IMEG Corp
855 GRANDVIEW AVENUE, 3RD FLOOR, COLUMBUS, OHIO 43215

ADDENDUM #1
TO THE SPECIFICATIONS & DRAWINGS FOR
FIRE ALARM UPGRADE PACKAGE 1 AT MULTIPLE SITES
CRANBROOK ES – SCOTTWOOD ES – WESTGATE ES
COLUMBUS CITY SCHOOLS
PROJECT #27007

This Document supplements and amends the original Drawings and Specifications issued and dated July 2, 2026, and shall be taken into account in preparing bids and shall become part of the Contract Documents.

A-100

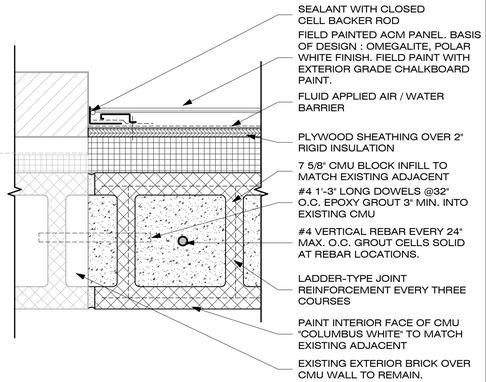
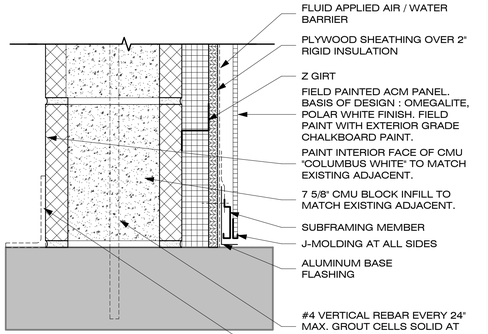
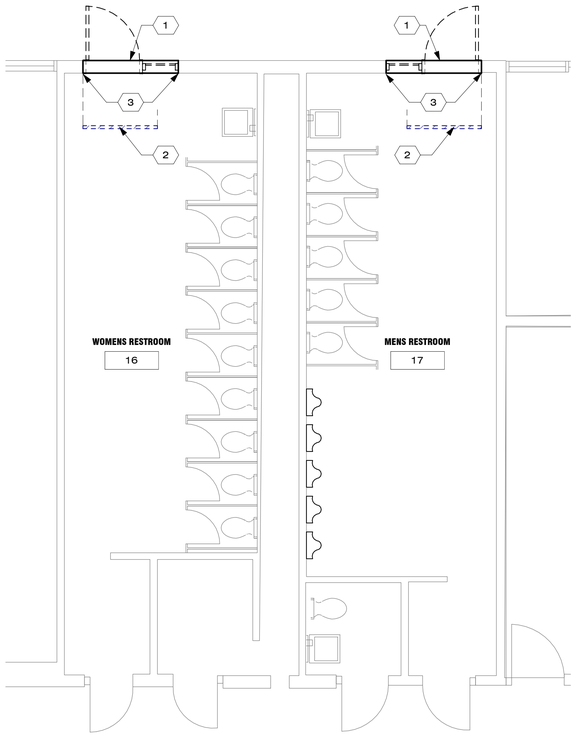
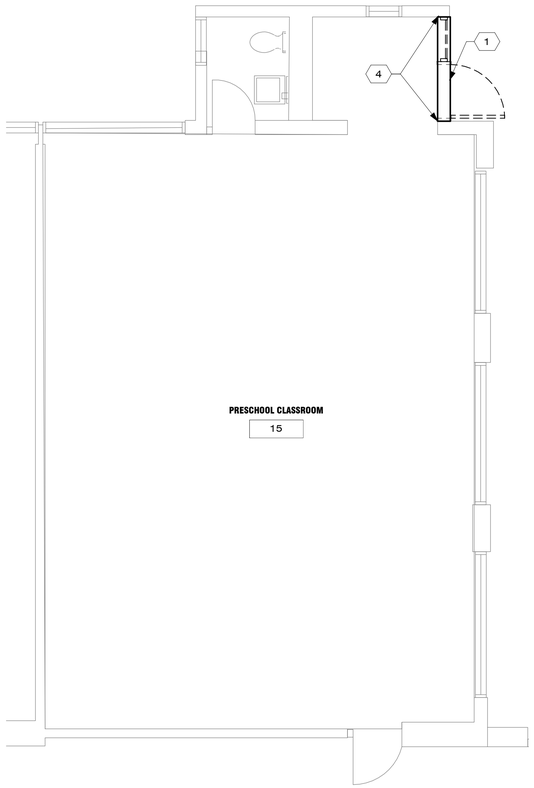
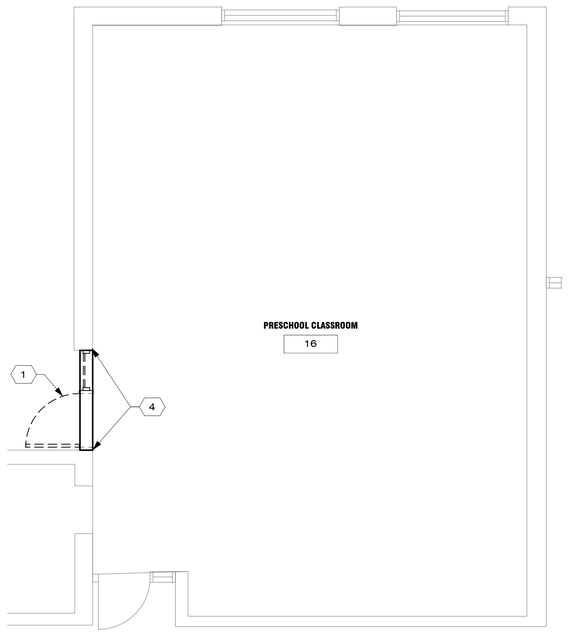
- DRAWINGS
  a. FA110:
     i. Existing exit signs added for removal in classrooms 15 and 16.
     ii. Classroom 16 door to be removed.
  b. A-100:
     i. Door and sidelite in classroom 16 added to scope.
     ii. Wall infill details revised.
     iii. Removal of toilet partitions in restrooms added to scope.
     iv. Existing conditions photos added.

A-100

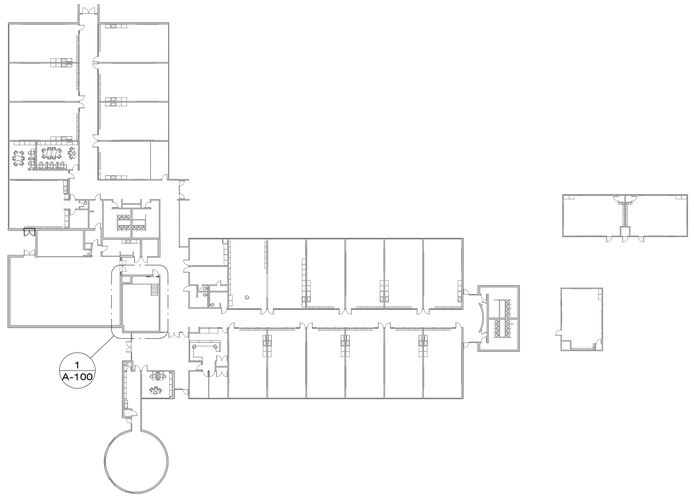
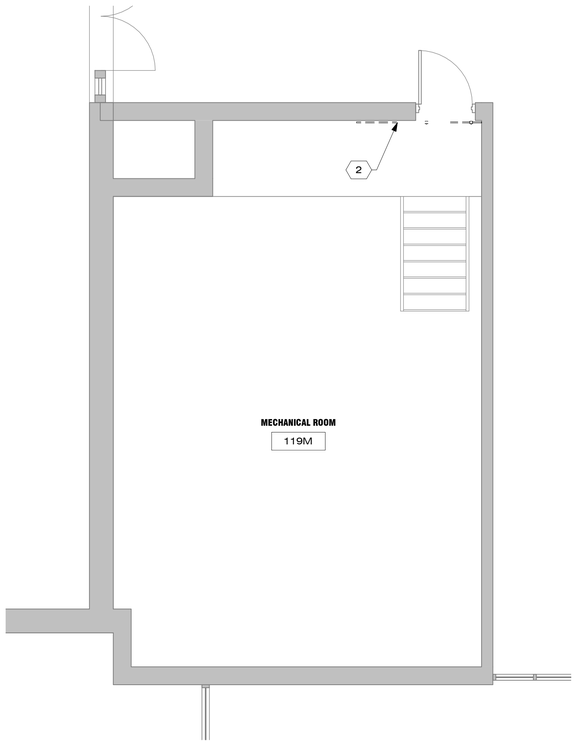
- DRAWINGS
  a. FA110:
     i. Classroom 133: Existing exterior door added to floor plan.
     ii. Modular units: locations of fire alarm devices revised to match existing locations.
  b. FA111: Classroom 133:
     i. Pull station and speaker/strobe added at existing exterior door.
  c. A-100:
     i. Door infill in classroom 133 removed from scope.
     ii. Wall infill details removed.
     iii. Existing conditions photos added.

A-100

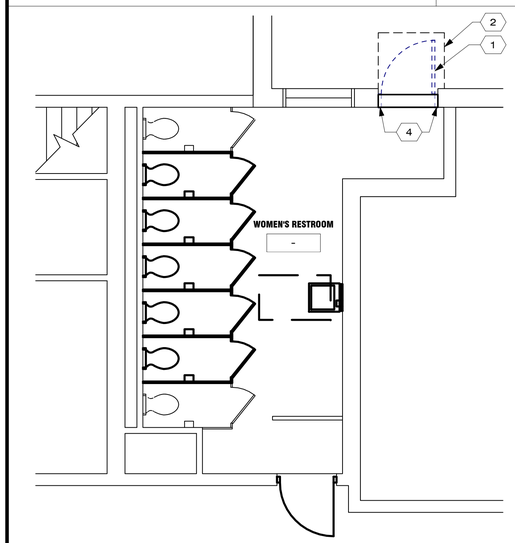
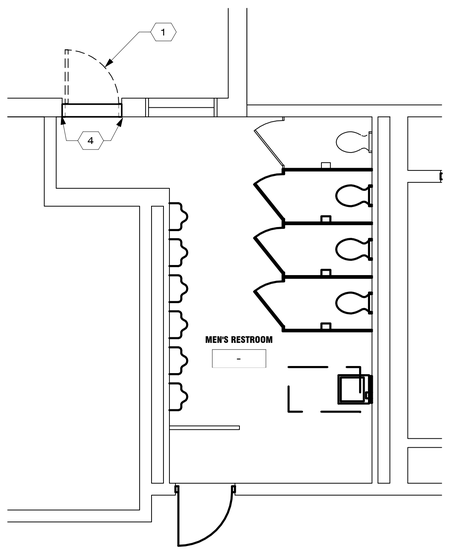
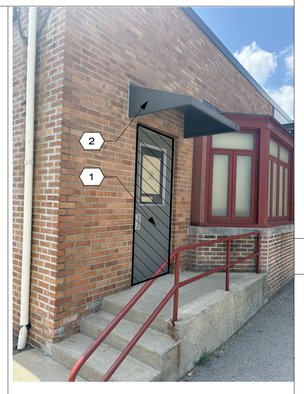
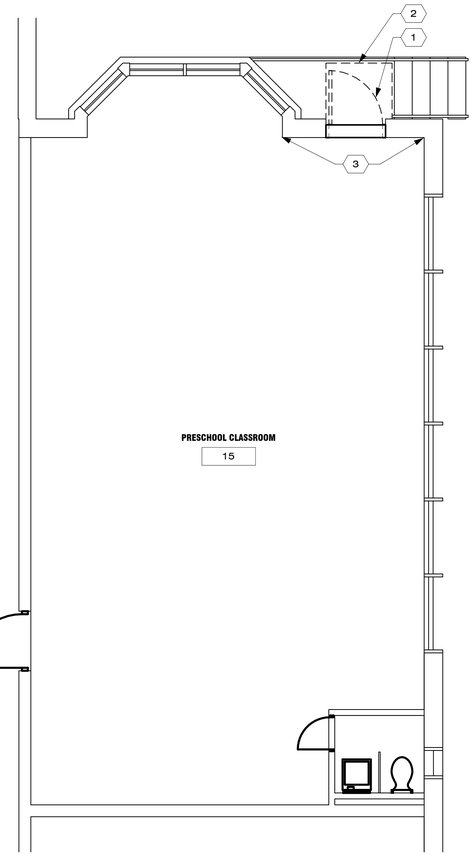
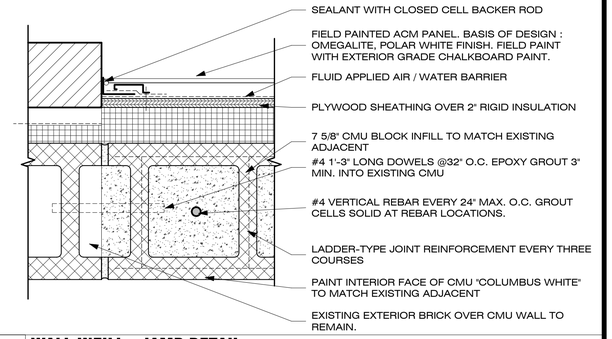
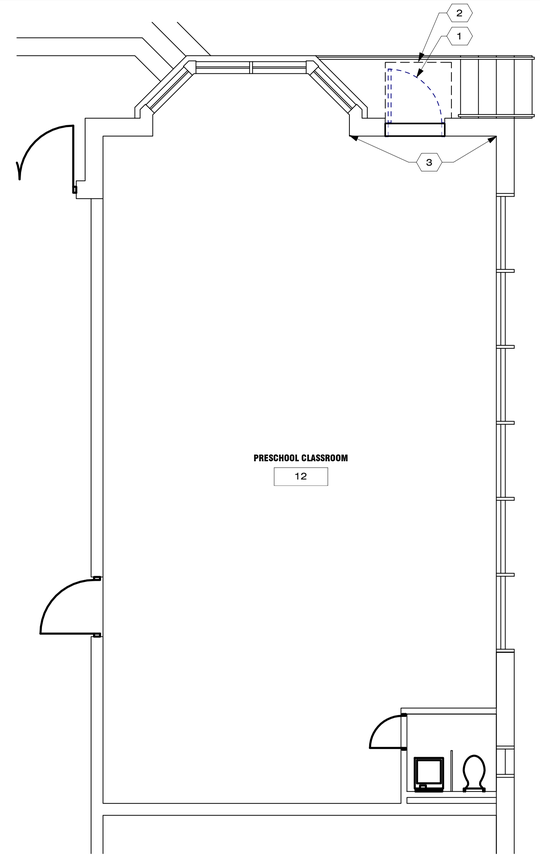
- DRAWINGS
  a. FA110:
     i. Corridor near classroom 18: existing exterior doors added to floor plan.
     ii. Plan note “A1” added.
  b. FA111:
     i. Corridor exterior doors near classroom 18: added a manual pulls station and speaker/strobe.
  c. A-100:

i. Wall infill details revised.
ii. Removal of canopies added to scope.
iii. Existing conditions photos added.

1 EXISTING DOOR, FRAME, HARDWARE, AND SIDELITES (IF APPLICABLE) TO BE REMOVED AND OPENING INFILLED. REFER TO WALL INFILL JAMB AND SILL DETAILS FOR PATCHING INFORMATION.
2 EXISTING CANOPY TO BE REMOVED. PATCH ANY HOLES FROM FASTENERS INTO BRICK AND ENSURE WATERTIGHT SEAL.
3 4" RESILIENT COVE BASE TO MATCH EXISTING ADJACENT.
4 COVE CMU PROFILE AT BASE
